PRODUCT CHANGE NOTIFICATION

Product Category GROUNDING PRODUCTS 20220405-01

Product Group POWER CONNECTORS GROUNDING AND STEEL

PZWMCGK

Photos/Drawing (where applicable)

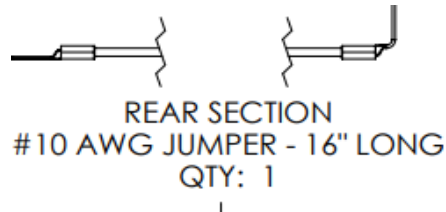
The 16" long grounding jumper for kit PZWMCG will be changing from a long barrel to a standard barrel 90 deg lug. This is a running change for the PZWMCG.
